RE: RPA NORTHWEST PRECINCT REDEVELOPMENT – RESPONSE TO TRAFFIC MATTERS

GTA Consultants has reviewed the traffic, on-site parking and loading matters as they relate to the Royal Prince Alfred Hospital (RPAH) Northwest Precinct Redevelopment and in particular comments by the Department of Infrastructure and Planning (DoPI), the City of Sydney (CoS) and Transport for NSW (TfNSW) in each respective letter of response to the project application (MP 10_0166) dated August 2012.

Attachment A

Brodie Street Shared Zone

RPAH NSW
SWEPT PATH ASSESSMENT
8.8m MEDIUM RIGID VEHICLE

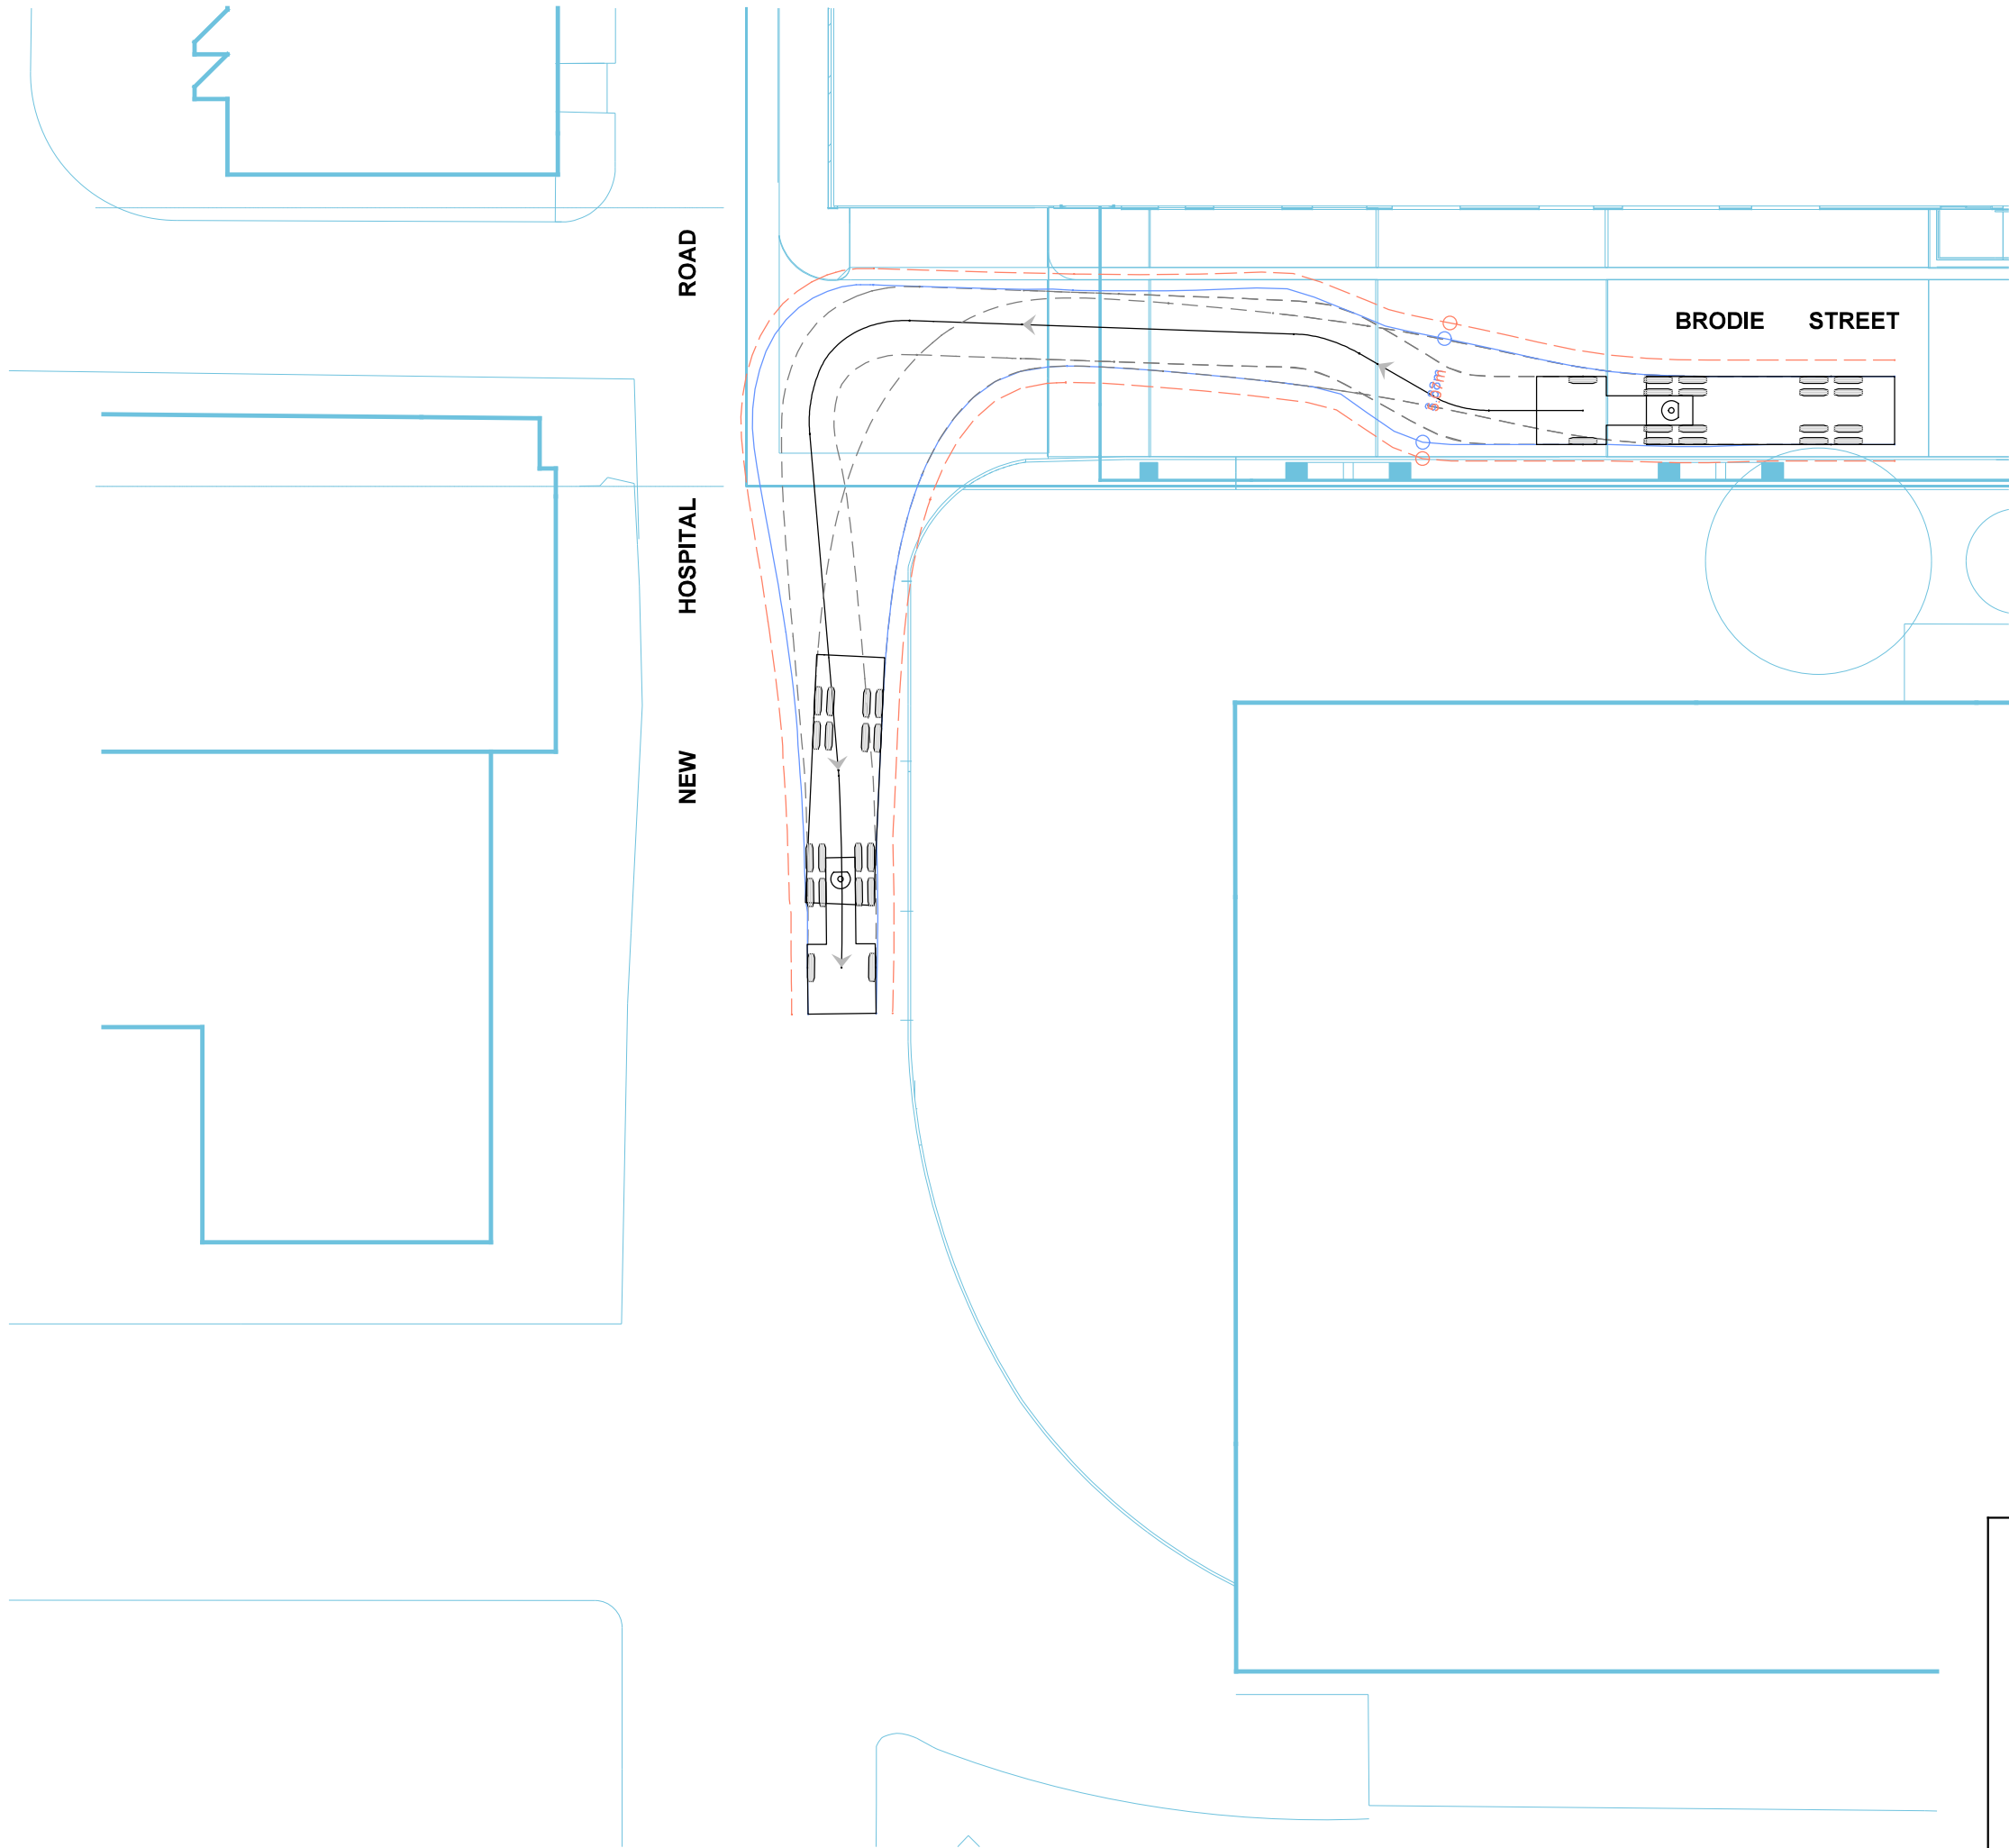
The loading dock is located at the western end of the shared zone with all service vehicles to enter the site via Missenden Road and Brodie Street and exit via New Hospital Road (south) and Grose Street. Swept paths of the largest vehicle requiring access to the loading Dock (8.8m medium rigid vehicle) are included in this response as Attachment B.

The proposed loading arrangements require manoeuvres that are considered to be unsafe. Specifically, the swept paths show that:

- i. vehicles entering and exiting the loading area will be required to perform u-turns and reverse through the intersection of Brodie and Hospital Road; and*
- ii. vehicles entering the loading area will also need to reverse through the proposed shared zone on Brodie Street.*

Both movements requiring manoeuvring and reversing through an intersection zone and vehicles entering the loading area also need to reverse in to a shared pedestrian zone. Both movements are considered unsuitable for a new development and it is recommended that the loading arrangements be reviewed and redesigned.

Swept paths show Service vehicles will exit the loading area via New Hospital Road (south) and then Grose Street to access Church Street west of the site. As such, no reversing or u-turns will be required on exit.

The shared zone has been amended to begin/ end adjacent to the eastern alignment of the loading dock resulting in service vehicles manoeuvring mostly within Brodie Street, west of the shared zone and adjacent to New Hospital Road. Swept paths are included in this response as Attachment B.
